Prepping CENPA for 4-Cavity Experiment

November 17, 2020

Task force to identify holes electronics wiring plan

Questions/Proposed Changes: Top Plate

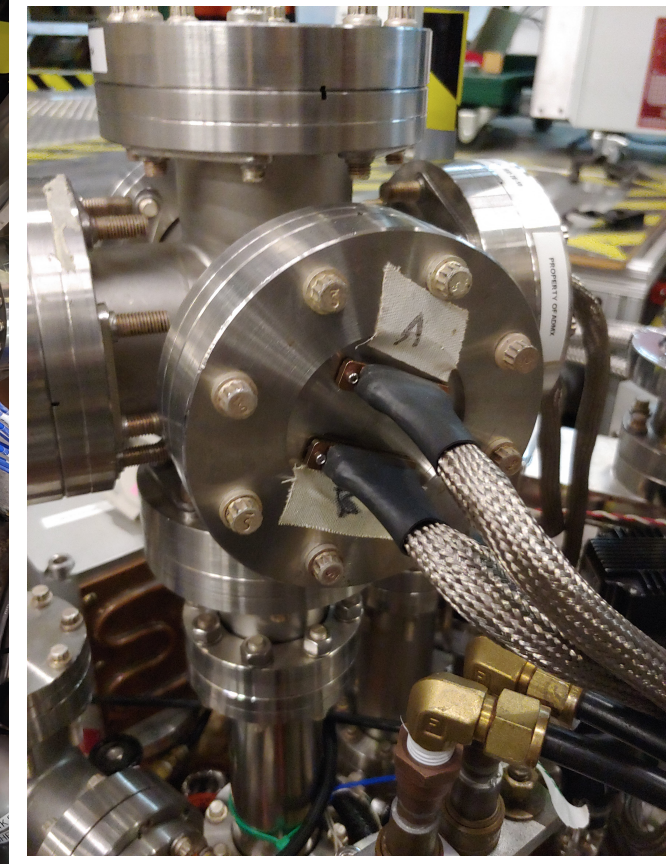
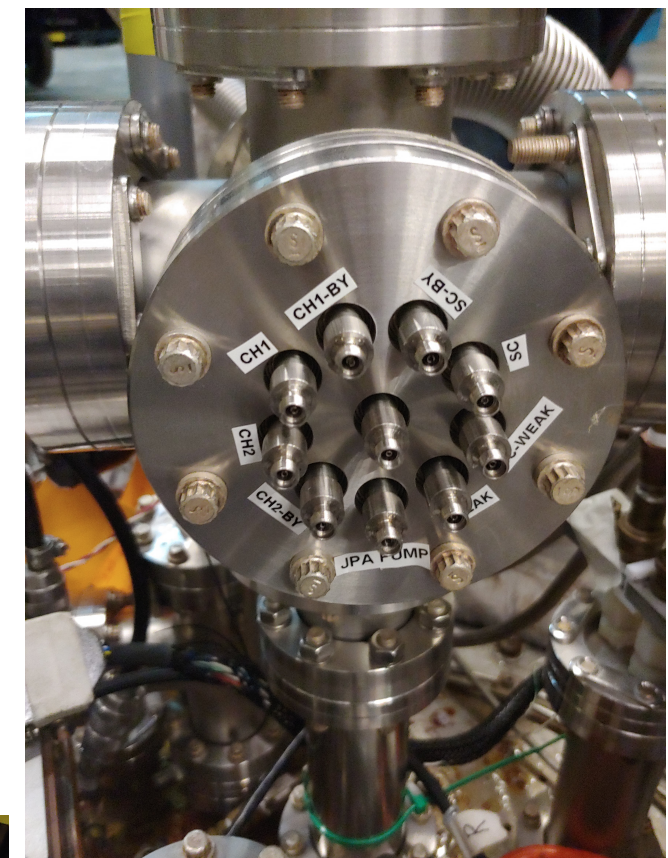
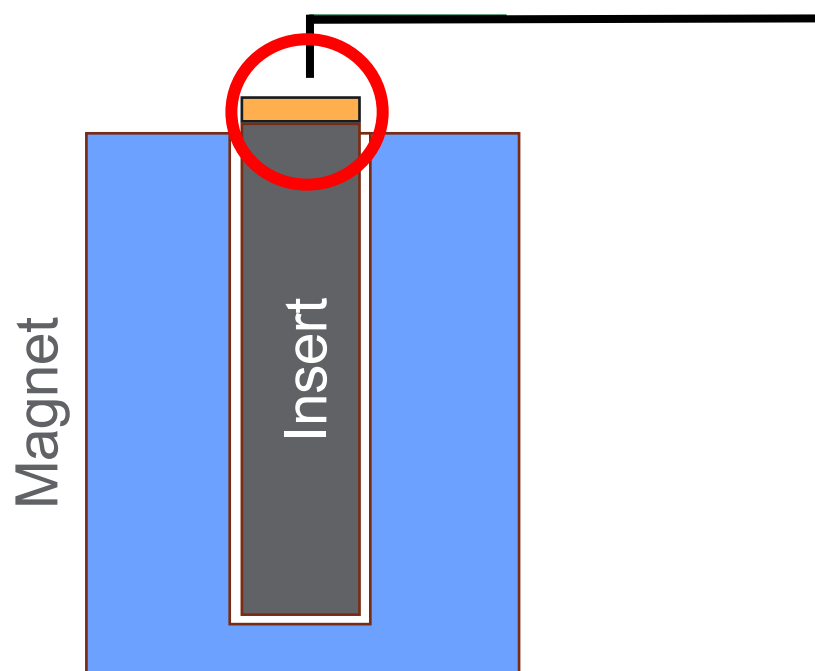
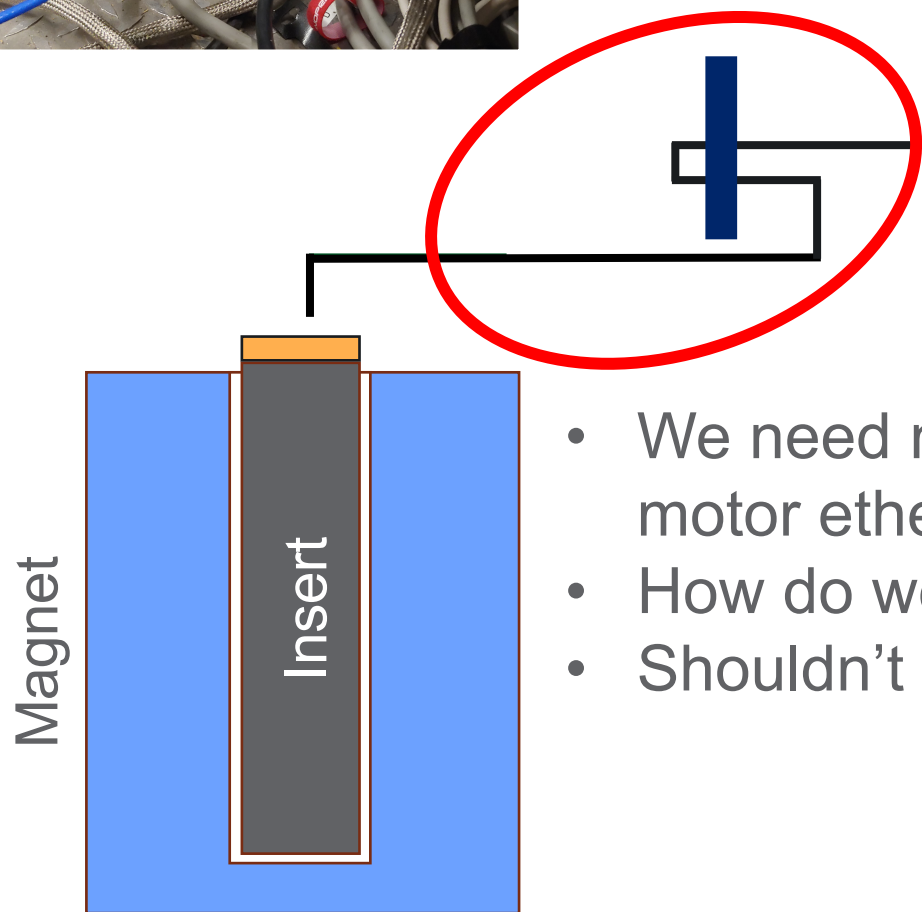
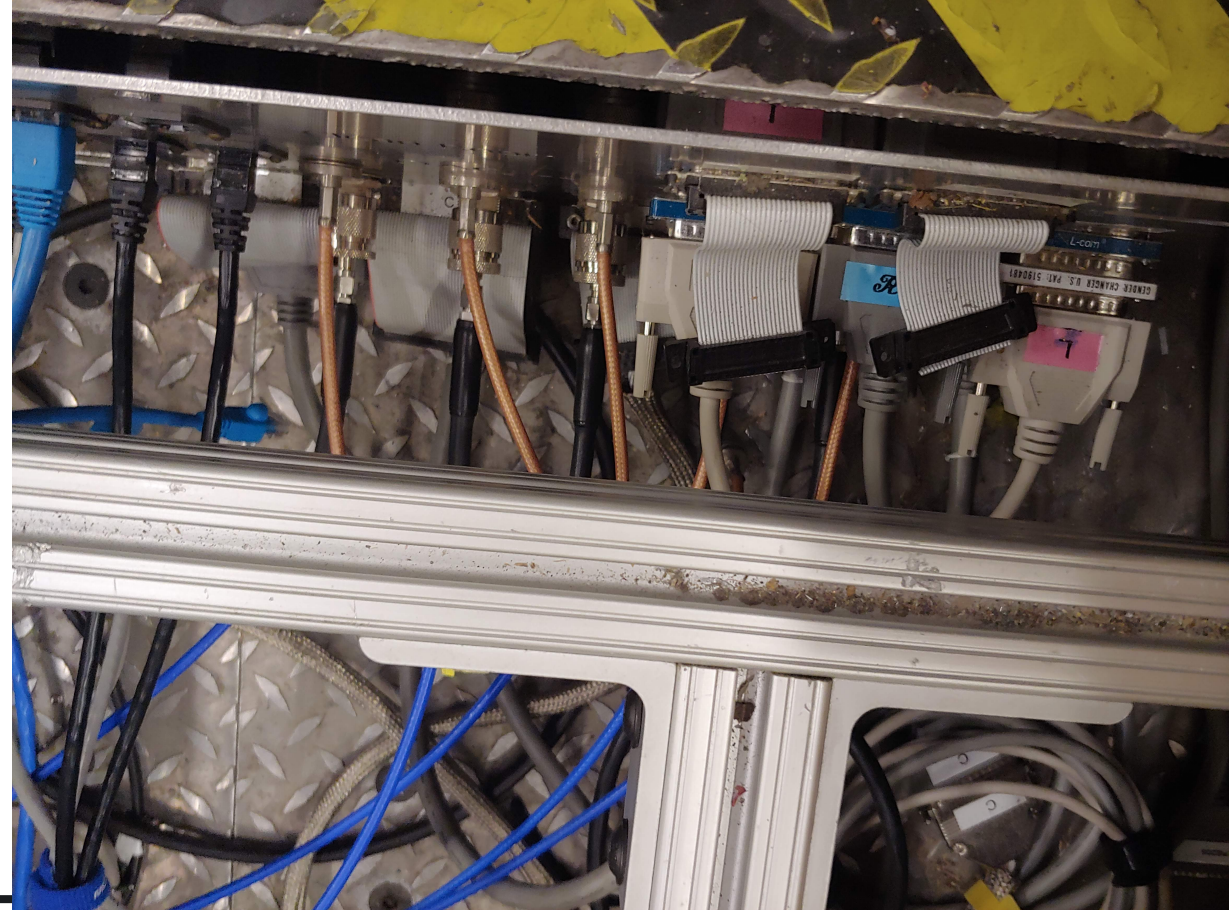
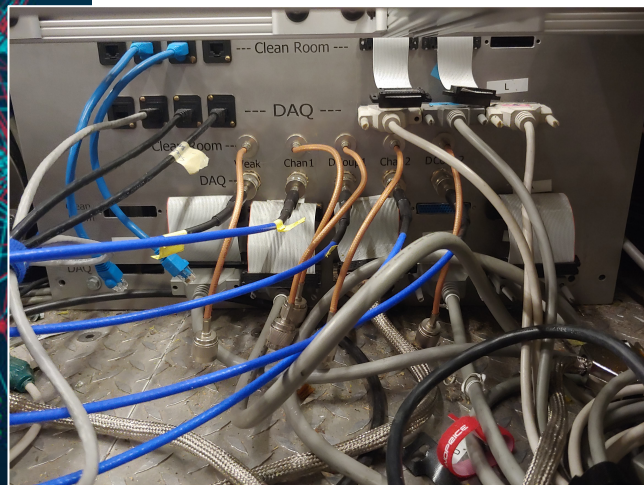
- What do we want actually going into insert?
- Will we have a Sidecar experiment?
- Should we break the densely packed hermetic feedthrough into two bulkheads?
- If we need to add an extra feedthrough (or cross) how do we do that without interfering with crane operations (expert: Doug Will)
- Should make plan for protecting hermetic feedthroughs
- Won't need stepper feedthroughs... should we use those ports?

Questions/Proposed Changes: Under diamond plate panels

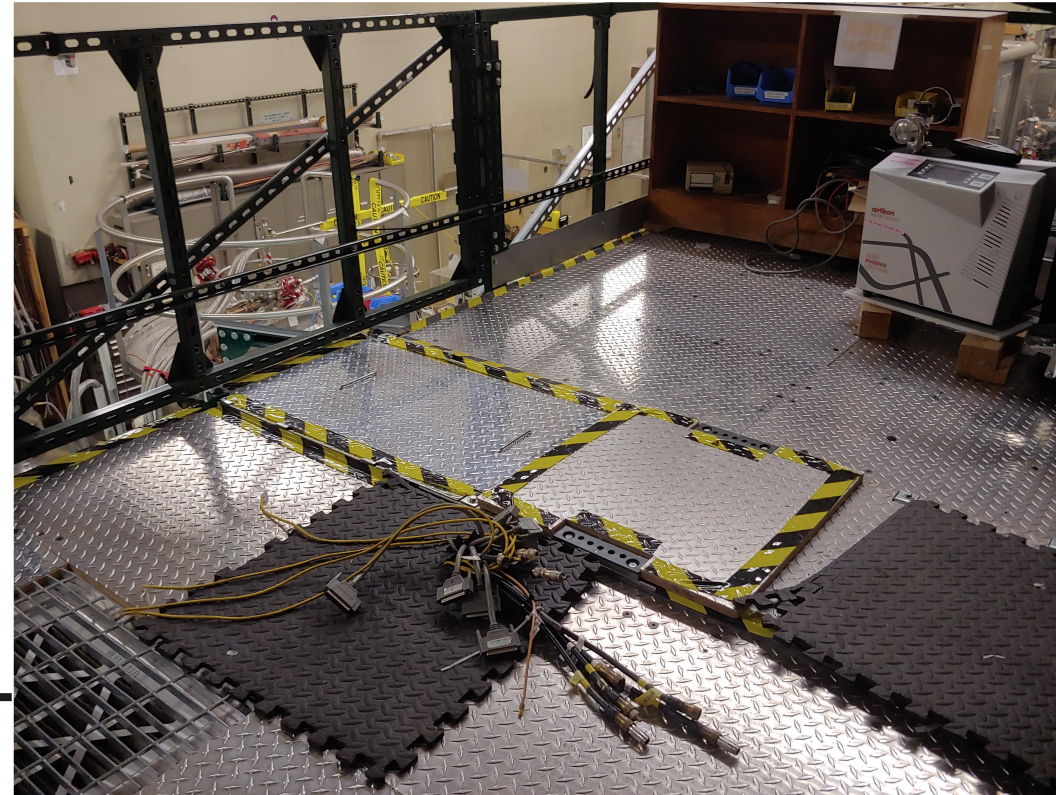
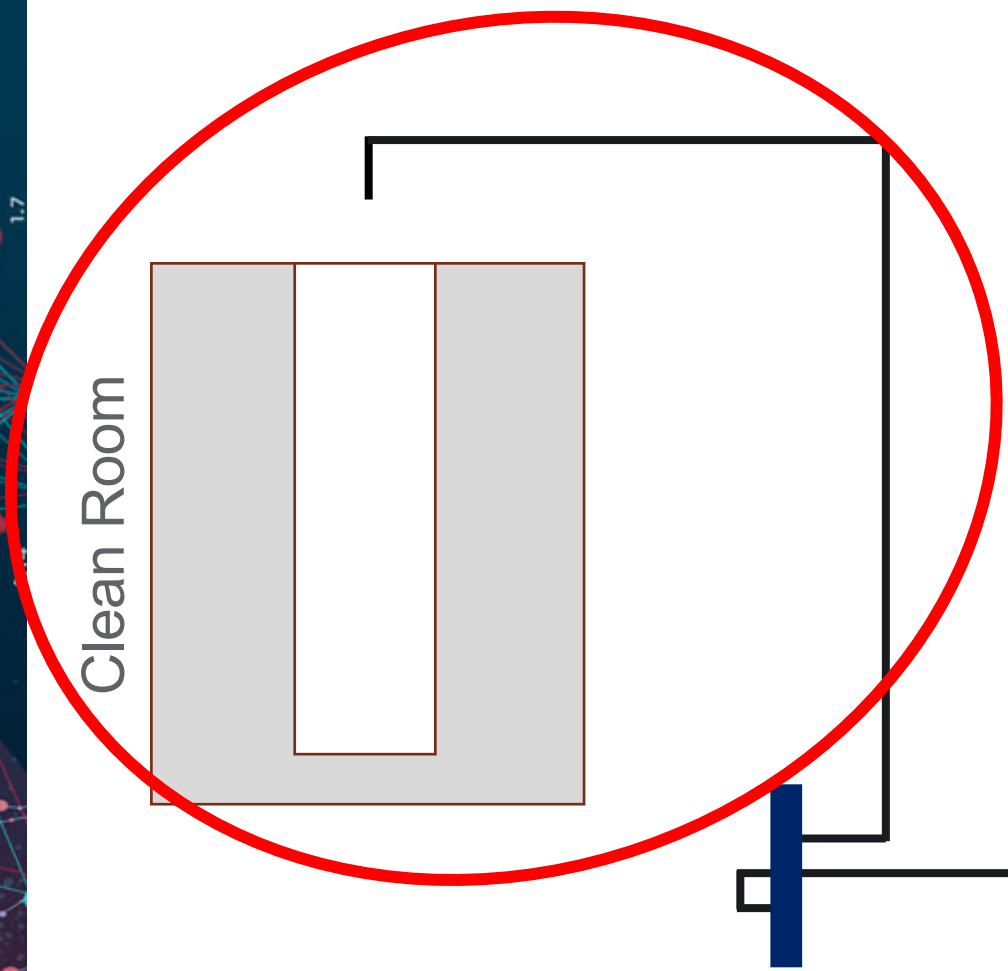
- We need many more RF lines – we don't need stepper motor ethernet cables. This should be remade!
- How do we avoid a tripping hazard?
- Shouldn't sensors be twisted pair? (expert: Hollister)

Questions/Proposed Changes: Clean Room

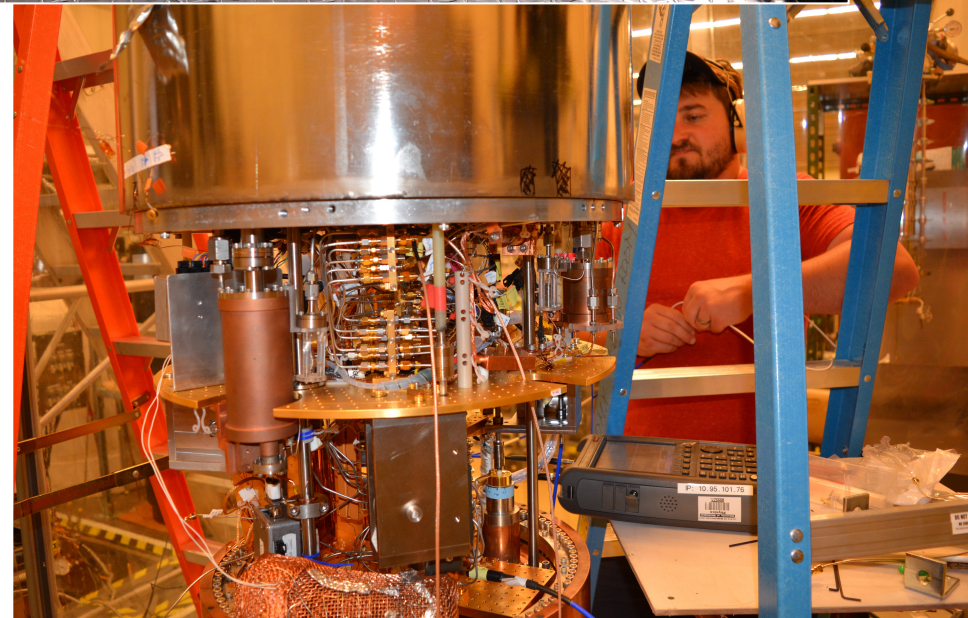
- Do we need more cables?
- Can we have a feedthrough panel at the top, that connects to a panel at the bottom for debugging purposes?

Questions/Proposed Changes: Long Cables/Racks

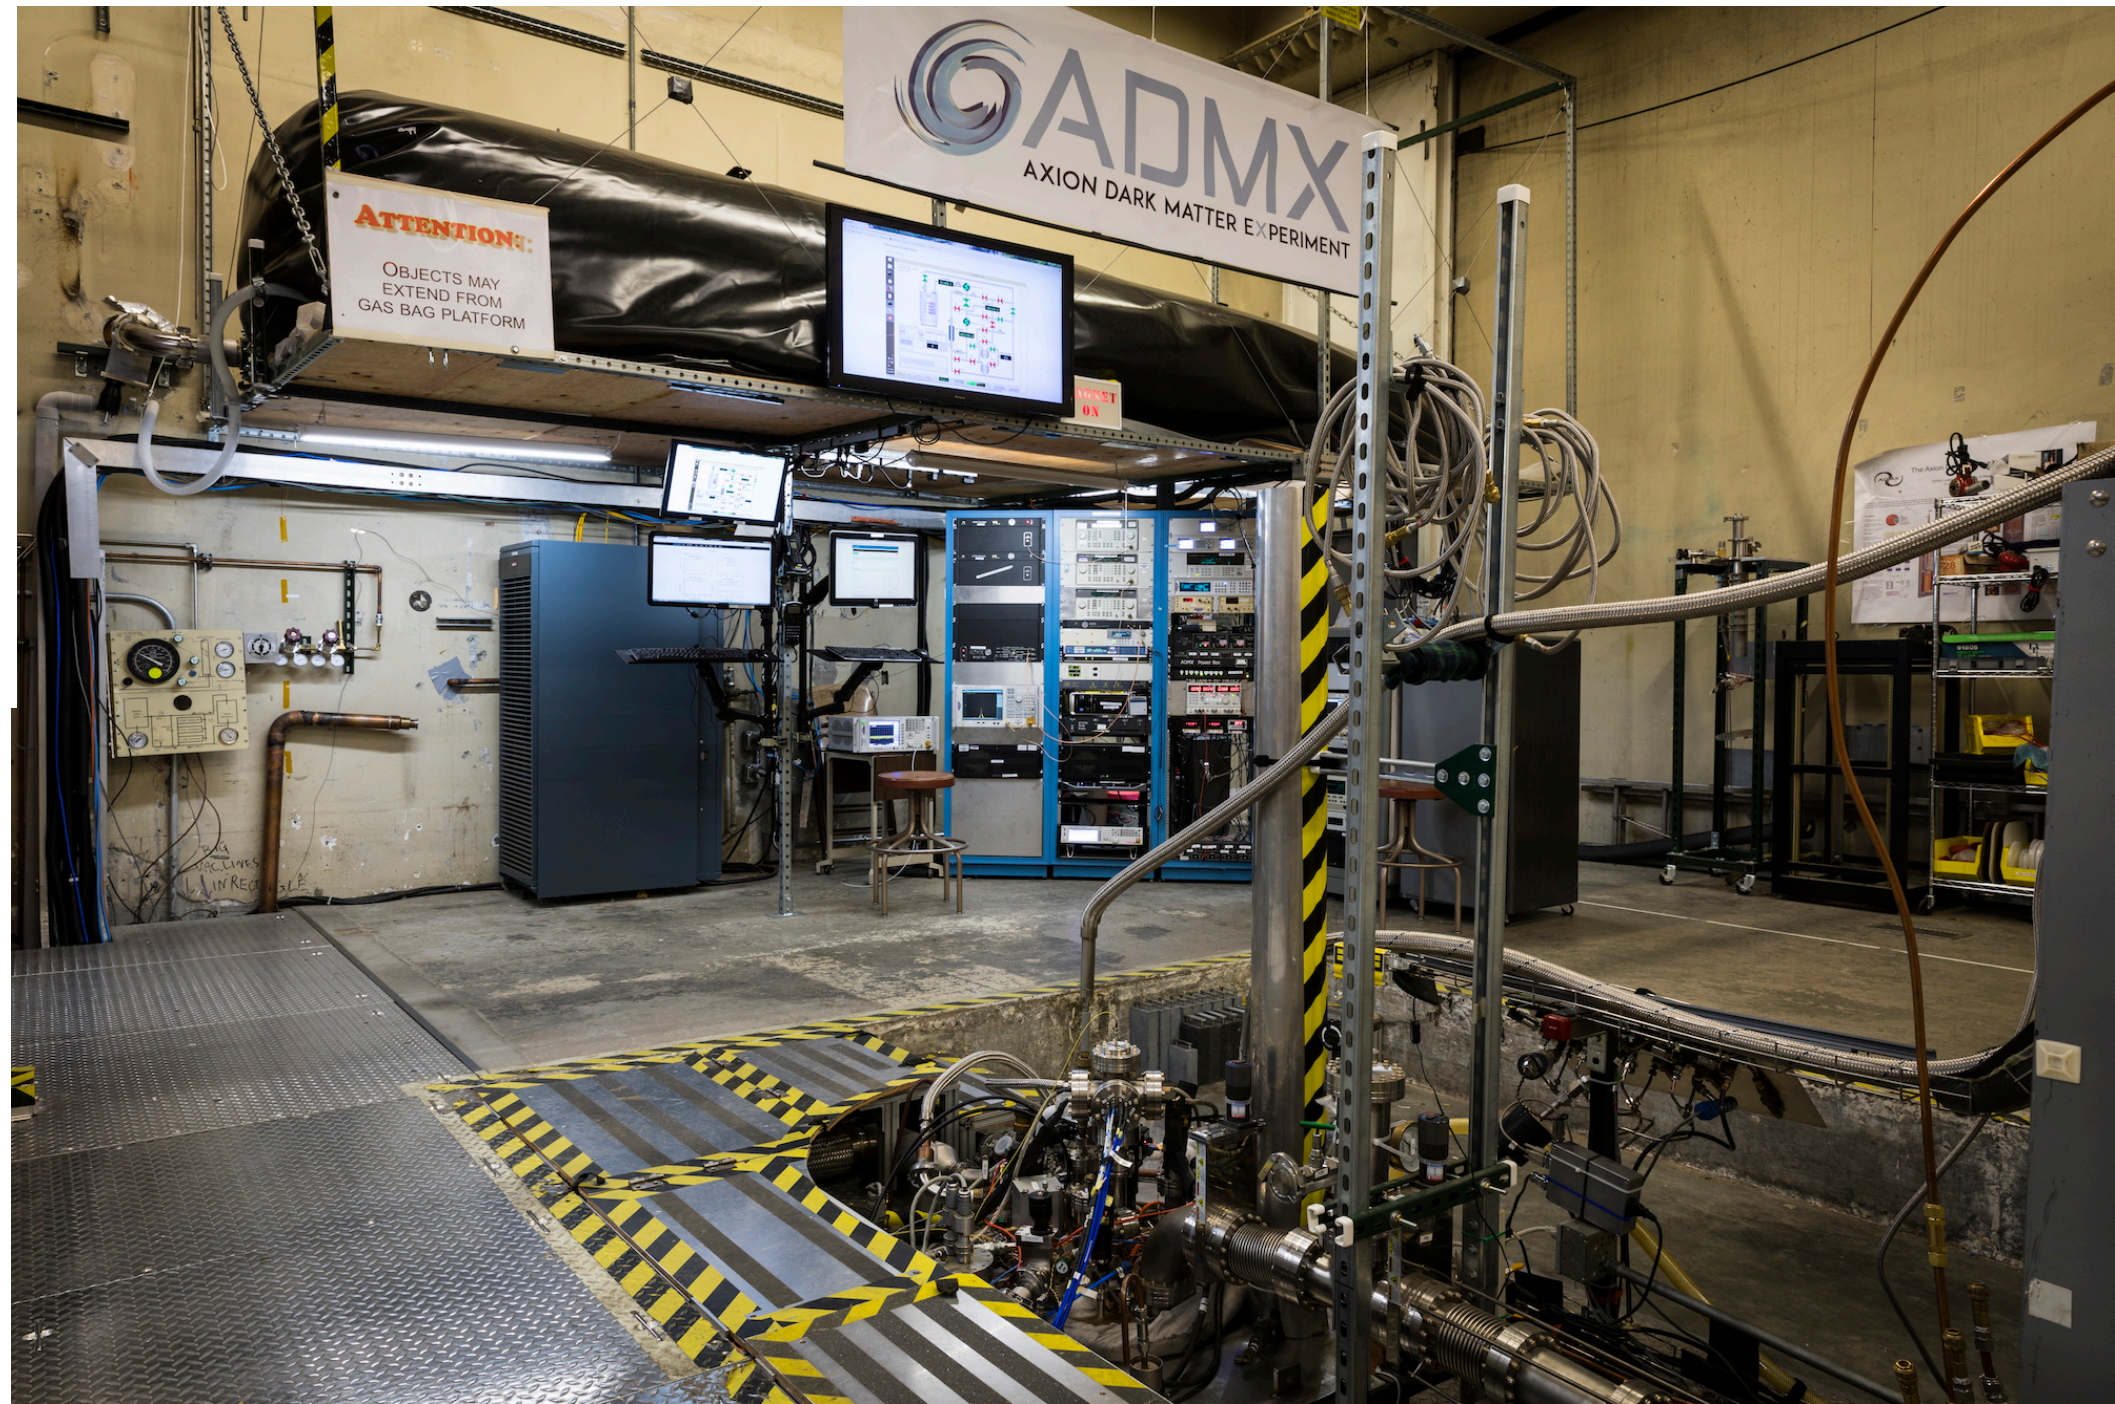
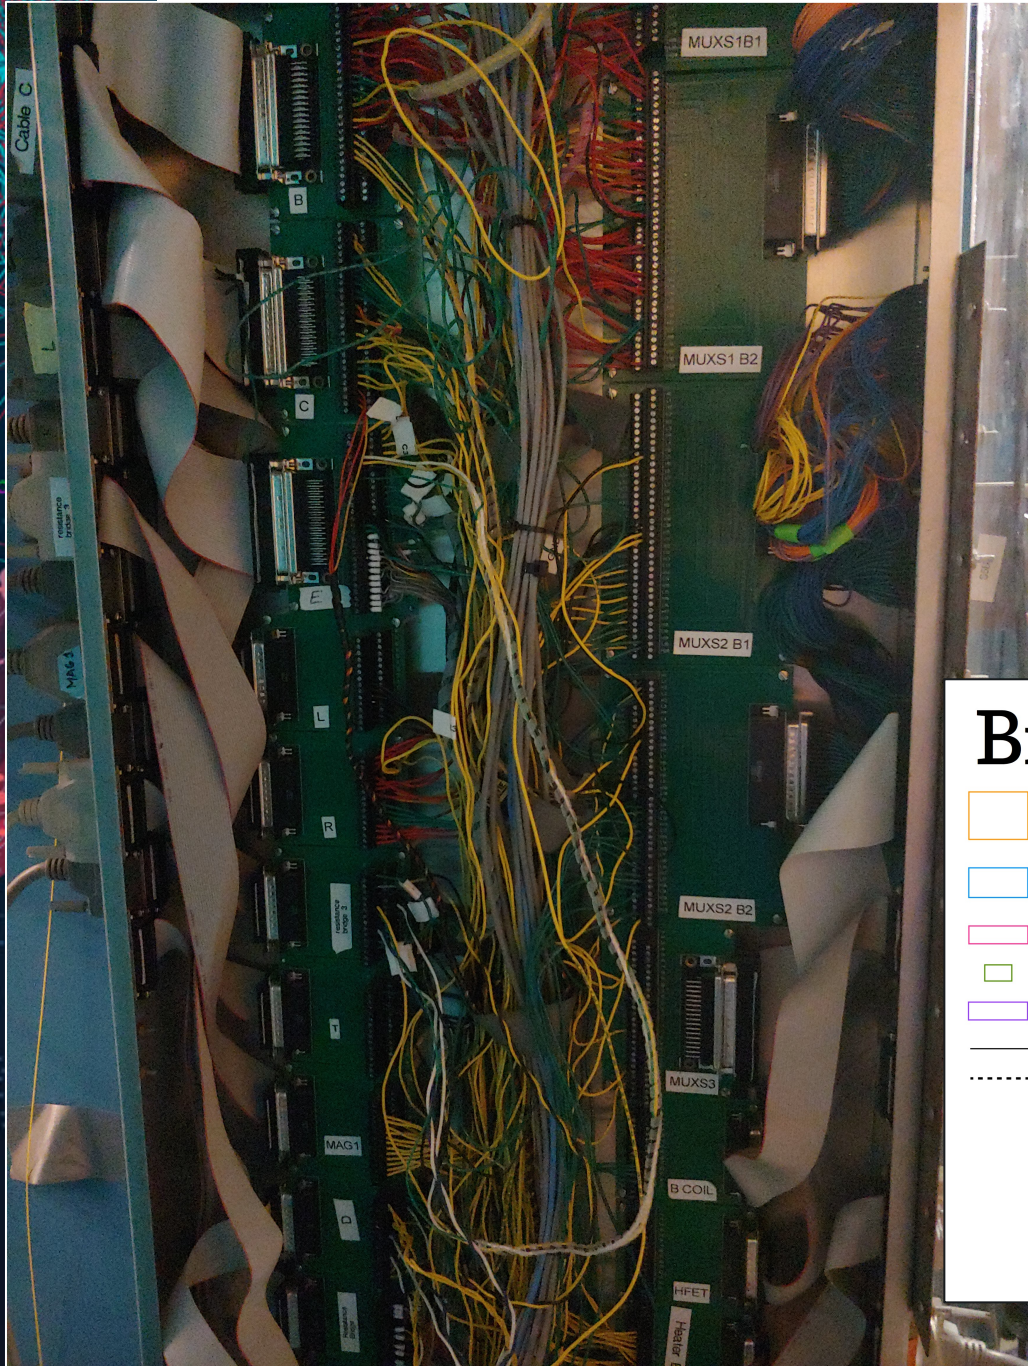
- We need to order more 50'+ Cables.
- Does the rack location still make sense?
- Does UW still have the 1-2 GHz receiver that PNNL sent to UW 4-5 years ago?
- Can we make the rack not load-bearing?

Questions/Proposed Changes: Breakout (nightmare) box

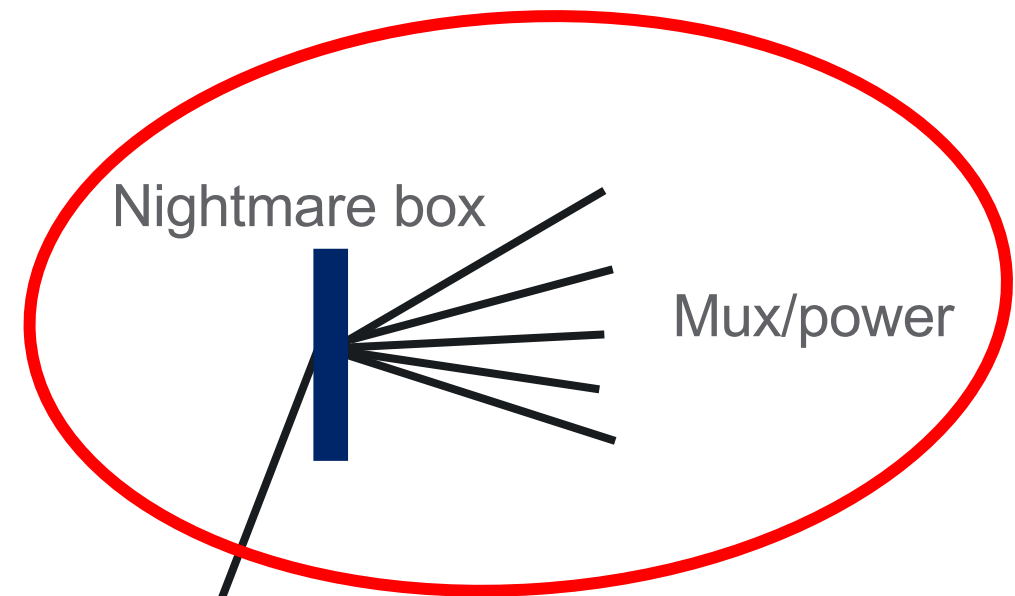
- What is going on?
- Have to match with what's going into insert
- 3 options:
 - a) keep it
 - b) toss it
 - c) phase it out slowly
